**BRIDGEPORT WEST SEWER IMPROVEMENTS
SECTION C – LIFT STATION IMPROVEMENTS
CITY OF SIOUX CITY, IOWA
Project No. 6827C-539-201 – 2016**

ADDENDUM NO. 2

March 3, 2016

SHEET NO.
C.03

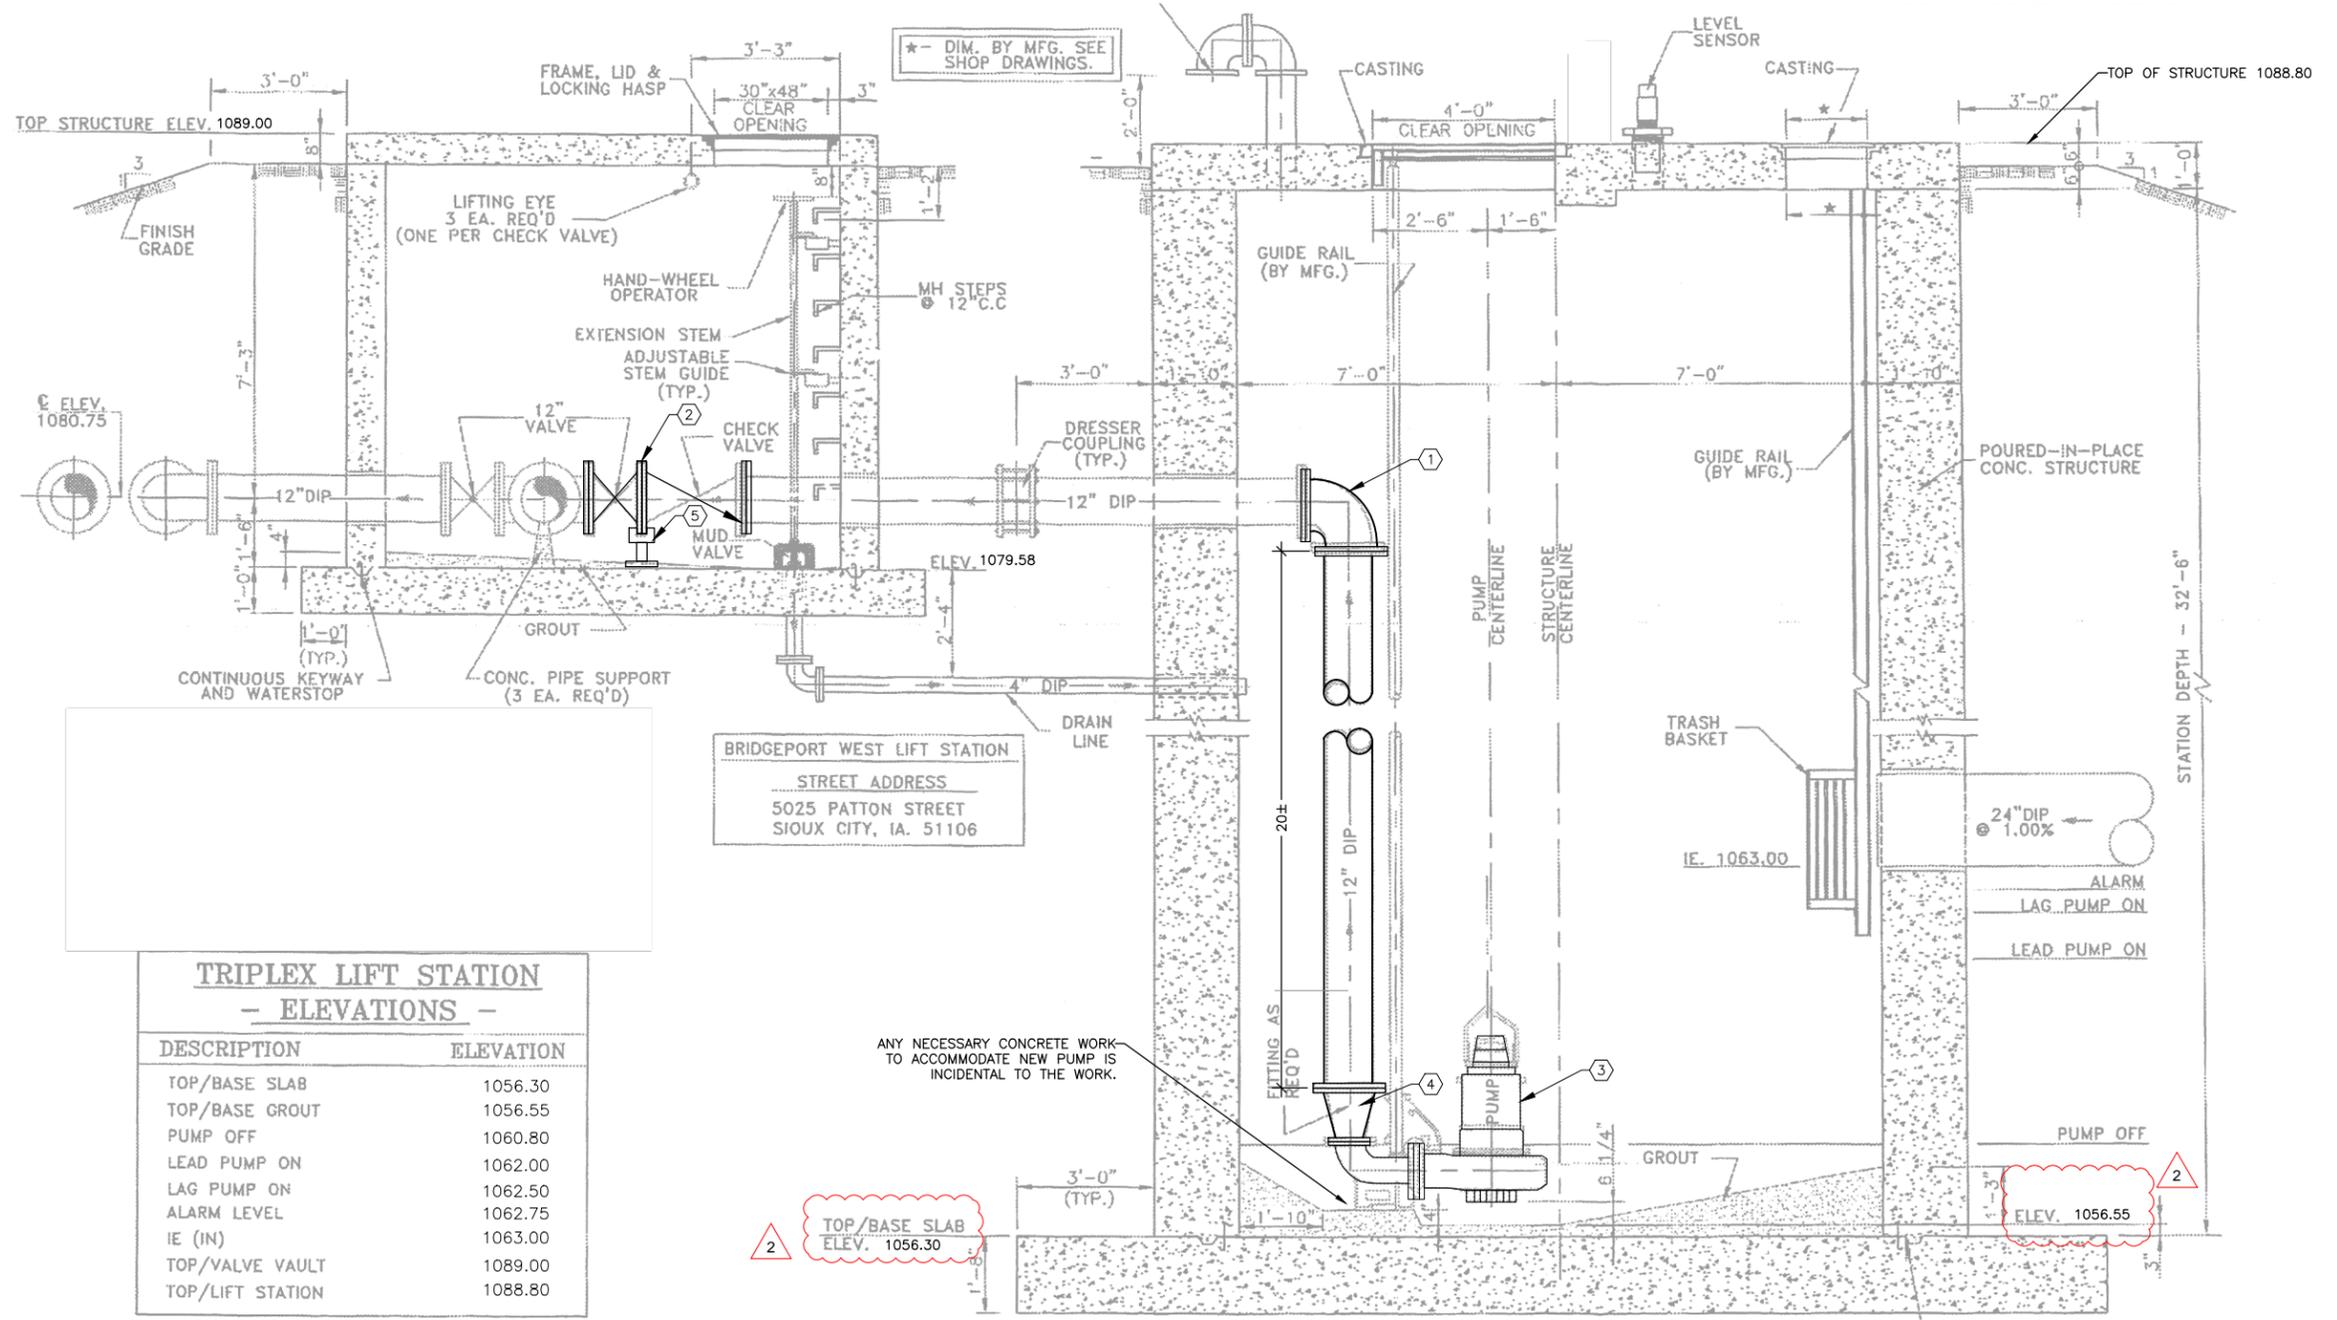
NO.	DATE	BY	REVISION DESCRIPTION
2	3/2/16	JV	ADD NEW ESTIMATE REFERENCE ITEMS

SHEET NO.
D.03

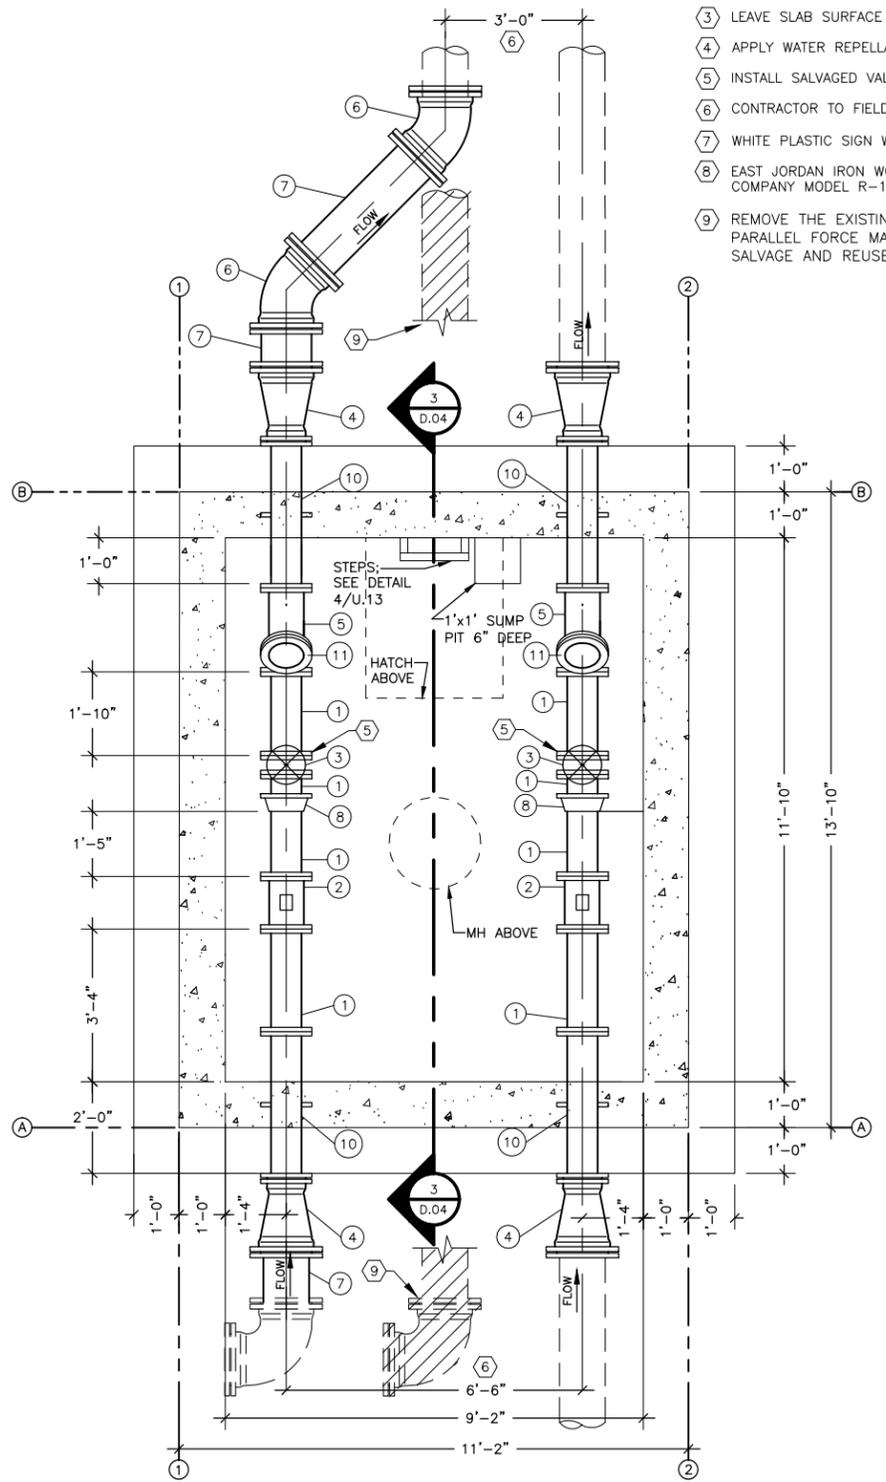
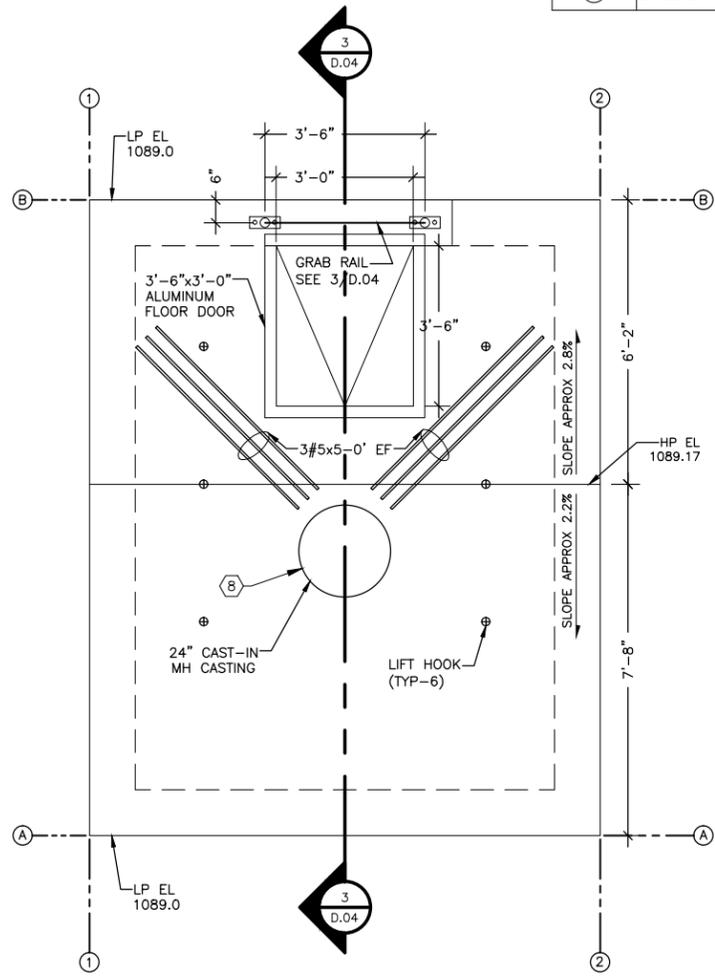
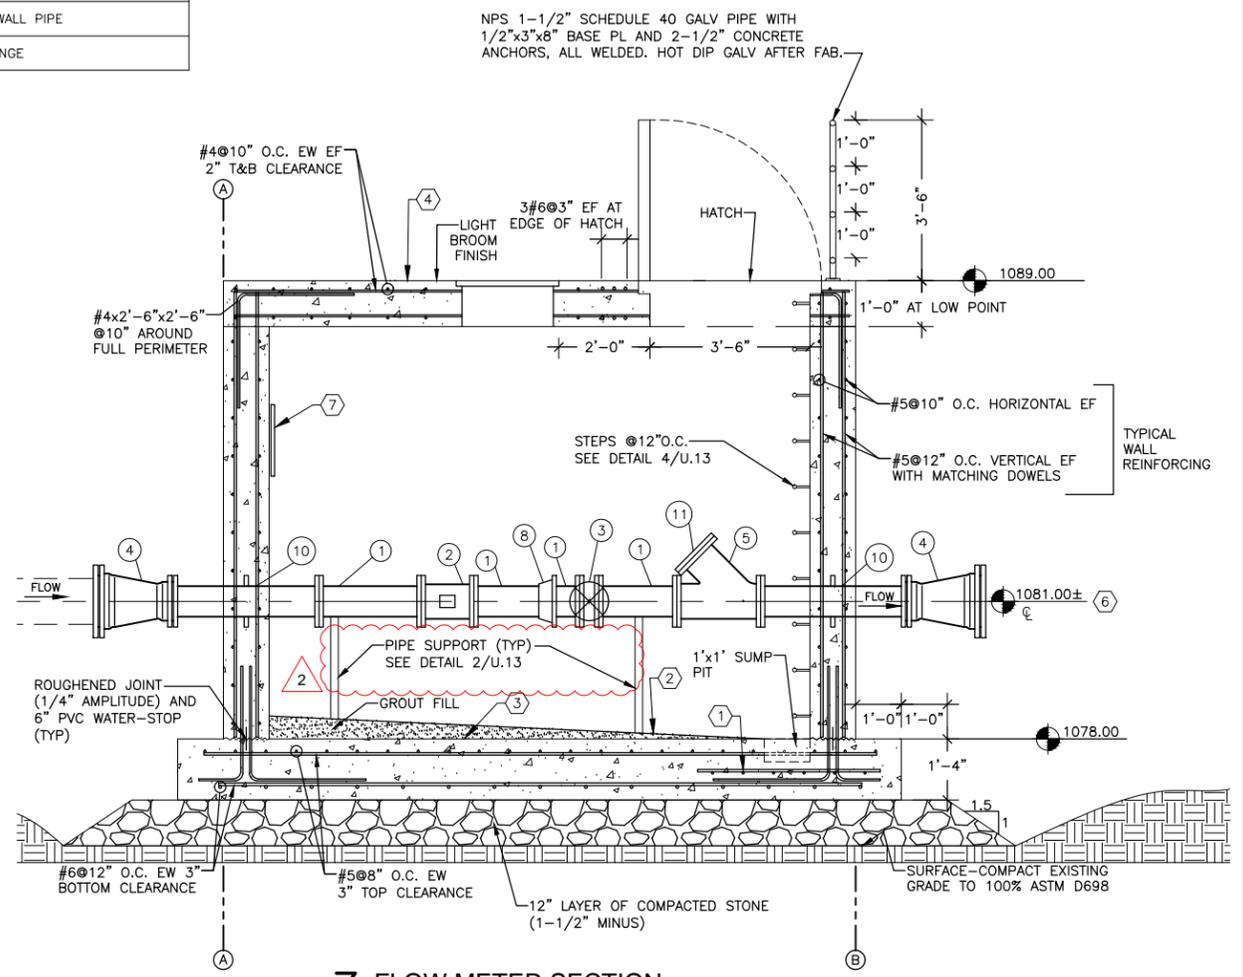
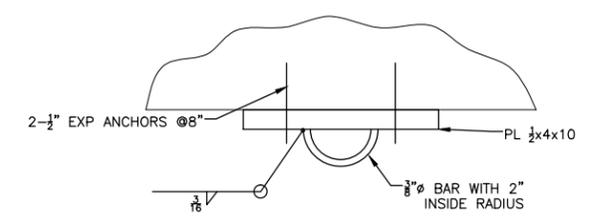
NO.	DATE	BY	REVISION DESCRIPTION
2	3/2/16	JV	REVISE EXISTING ELEVATIONS

SHEET NO.
D.04

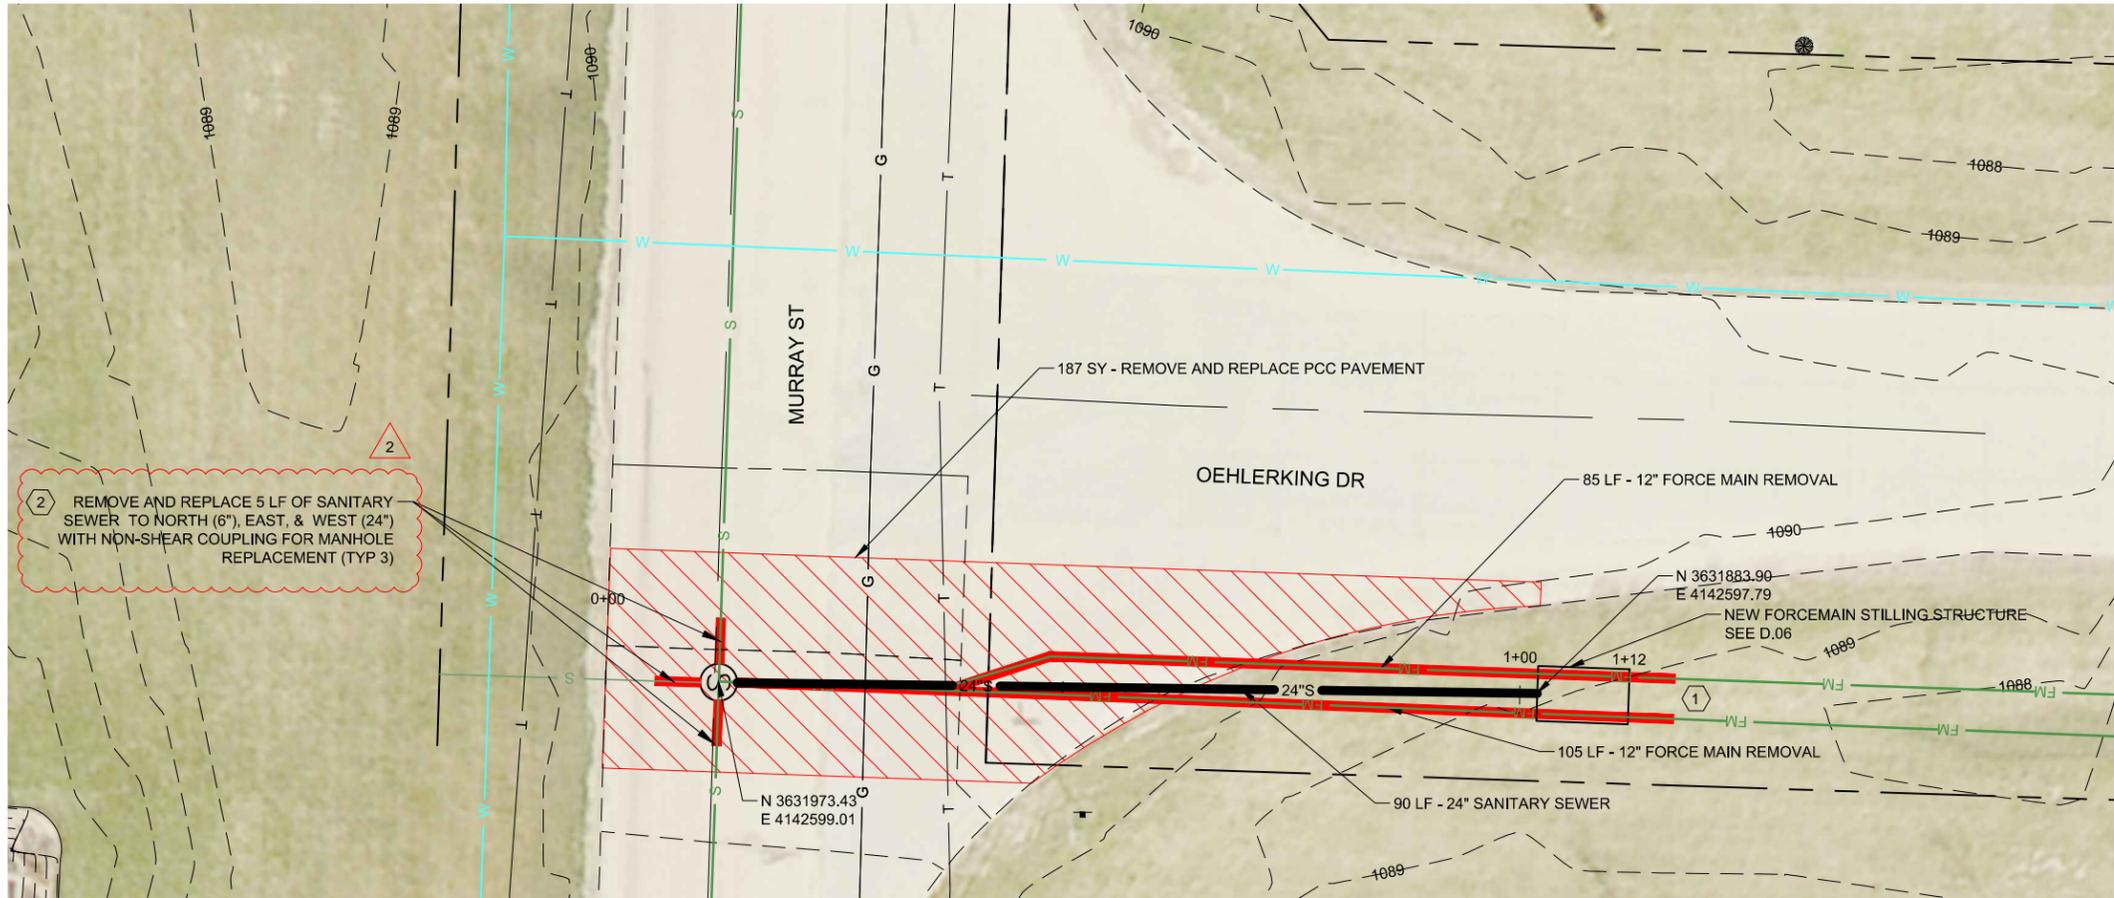
NO.	DATE	BY	REVISION DESCRIPTION
2	3/2/16	JV	ADD PIPE SUPPORT NOTE

SHEET NO.
D.05

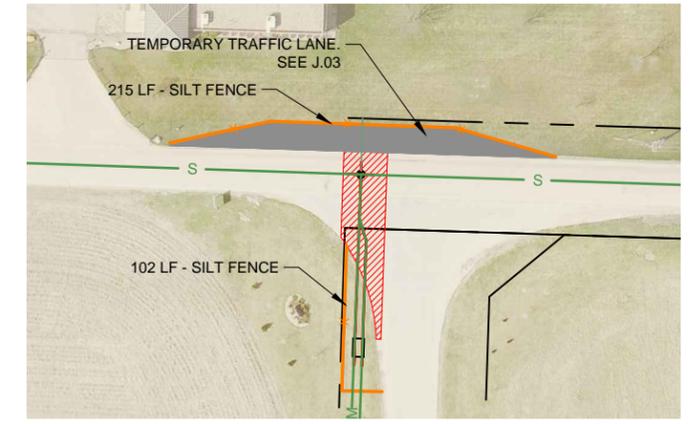
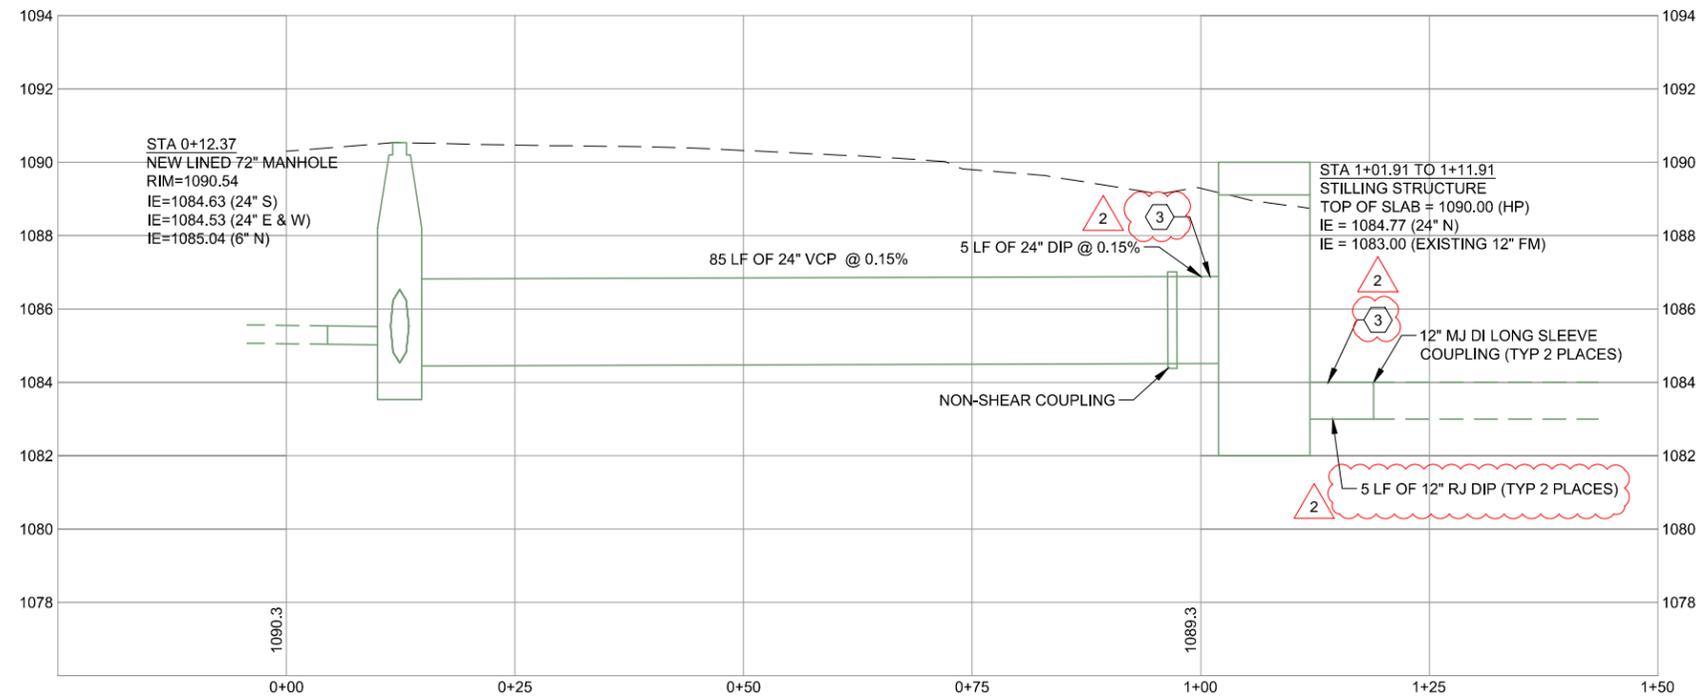
NO.	DATE	BY	REVISION DESCRIPTION
2	3/2/16	JV	REVISE PIPE REMOVAL NOTE, ADD KEY NOTE 3

- ① FORCE MAIN LOCATION IS APPROXIMATE. FIELD VERIFY LOCATION OF EXISTING FORCE MAIN PRIOR TO BEGINNING WORK AND NOTIFY ENGINEER OF ANY DISCREPANCIES. COORDINATE FINAL LOCATION OF FLOW METER STRUCTURE WITH ENGINEER. PROVIDE SURVEY OF FINAL 4 CORNER LOCATIONS.
- ② NON-SHEAR COUPLING TO HAVE STAINLESS STEEL BOLTS AND NUTS.
- ③ SEE D.06 FOR PIPE CONNECTIONS INTO STILLING STRUCTURE.
